Braidwood Station, Units 1 and 2  
Facility Operating License Nos. NPF-72 and NPF-77  
NRC Docket Nos. STN 50-456 and STN 50-457

Subject: Response to Request for Additional Information for Technical Specifications  
Change to Revise Steam Generator Inspection Frequency for the Fall 2001  
Refueling Outage for Braidwood Station, Unit 1

### **Response to Request for Additional Information for Technical Specifications Change to Revise Steam Generator Inspection Frequency for the Fall 2001 Refueling Outage for Braidwood Station, Unit 1**

**FIGURE A**

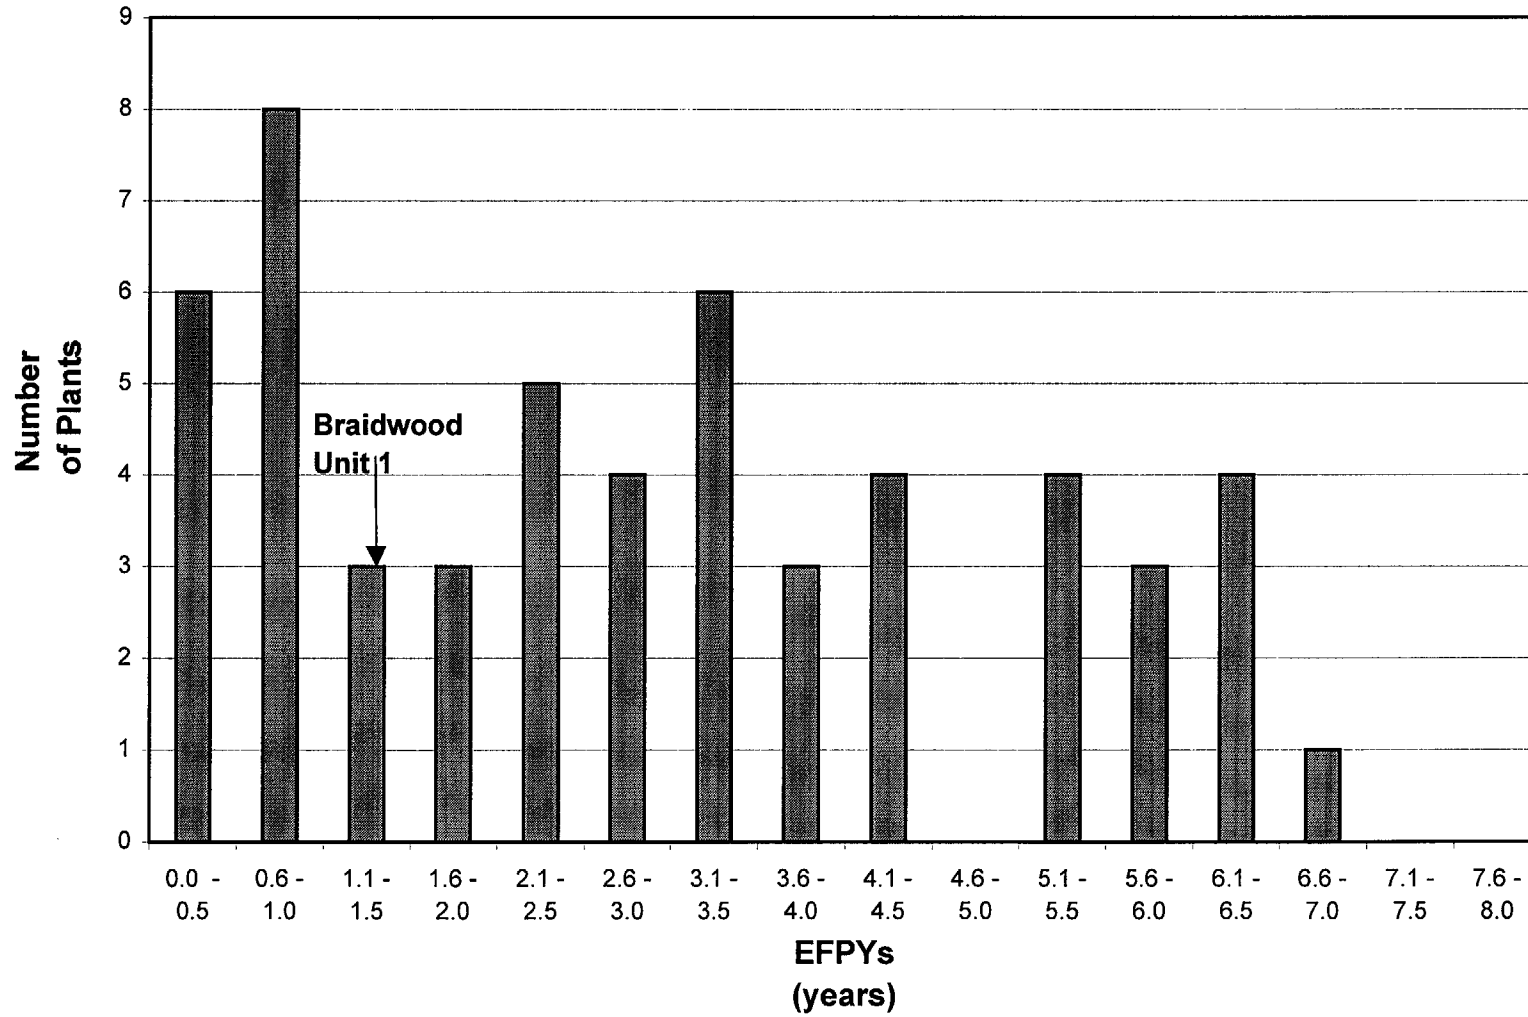
"On page 11 of Attachment A in the submittal, the licensee summarized industry experience of the RSGs with Alloy 690 tubing. Please briefly discuss the relevance of the experience in comparison of operating conditions, such as  $T_{hot}$  and water chemistry."

In a comparison of the Braidwood Station, Unit 1 RSG operating time in EFPYs to other units containing thermally treated Inconel-690 tubing, 38 of the 54 units have more operating time than Braidwood Station, Unit 1. To date, no units have reported any signs of degradation other than that associated with tube wear. This further supports our position that IGA and SCC will not develop early in the life of the SGs containing thermally treated Inconel-690 tubing and that SG inspections are not warranted during the upcoming Braidwood Station, Unit 1 fall 2001 refueling outage (see Figure A).
